Access Compliance Report

Public Rights-of-Way

(Curb Ramps)

Intersection ID: 10029623	Main Street: KING LOUIS CT	Cross Street: N/A	Location: NE
ADA ID: 425114695EA2	Ramp Type: BlendTrans2	Initial Pass/Fail: Fail	Overall Compliance: No
Severity Score: 8.75			
Codes/Mitigation Info/Possible Solution		Field Measurements/Component Compliance

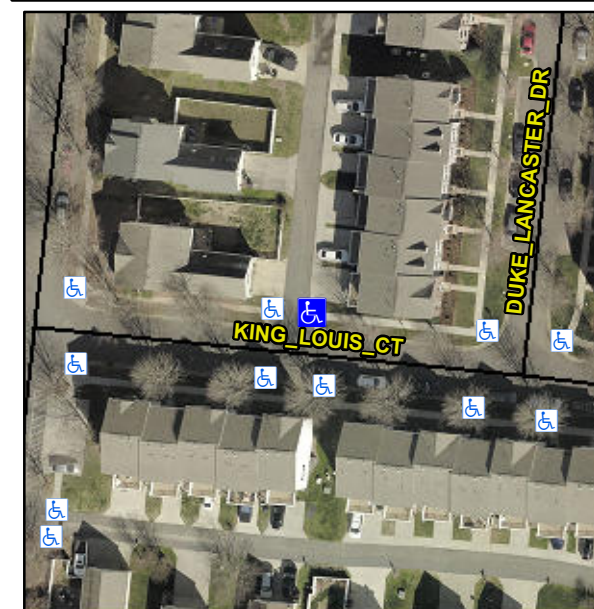
Not Found, R304.5.1

Compliance	Description	Data	Compliance	Description	Data
N/A	Ramp Length (in)	58.0	Yes	BlendTrans Slope (%)	4.4
No	Ramp Width (in)	36.0	Yes	BlendTrans XSlope (%)	1.2
N/A	Flare Type LT	N/A	N/A	Flare Type RT	N/A
N/A	Flare Slope LT (%)	N/A	N/A	Flare Slope RT (%)	N/A
N/A	Flare Traversable LT?	N/A	N/A	Flare Traversable RT?	N/A
N/A	Landing Length (in)	N/A	N/A	DWS Provided?	N/A
N/A	Landing Width (in)	N/A	N/A	DWS Contrast?	N/A
N/A	Landing Slope (%)	N/A	N/A	DWS Length (in)	N/A
N/A	Landing X Slope (%)	N/A	N/A	DWS Full Width?	N/A
N/A	Landing Curb? (Y/N)	N/A	N/A	DWS Offset (in)	N/A
N/A	Shared Landing?	N/A			
N/A	Gutter Ponding?	N/A	N/A	Gutter Slope (%)	N/A
N/A	Gutter Lip Ht (in)	N/A	N/A	Gutter X Slope (%)	N/A
N/A	Painted X Walk1?	No	N/A	Painted X Walk2?	No
	X Walk 1 Direction	To W		X Walk 2 Direction	To S
	X Walk 1 Width (in)	N/A		X Walk 2 Width (in)	N/A
	X Walk 1 Slope (%)	2.0		X Walk 2 Slope (%)	0.3
	X Walk 1 X Slope (%)	0.0		X Walk 2 X Slope (%)	0.9

N/A	Ramp inside XWalk1?	N/A	N/A	Ramp inside XWalk2?	N/A
	Road Slope (%)	0.1		Clear Space?	N/A
	Road X Slope (%)	1.8	N/A	Clear Space to XWalk (in)	N/A
N/A	Any Obstructions?	N/A	N/A	Storm Grate/Utility Hazard?	N/A
	Obstruction Type			Storm Grate/Utility Type	
		N/A			N/A
			Yes	Surface Condition? (G/P)	Good
			No	Curb Slope (%)	20.6

Remove & Replace Curb Ramp With Two New Directional Ramps or Equivalent.
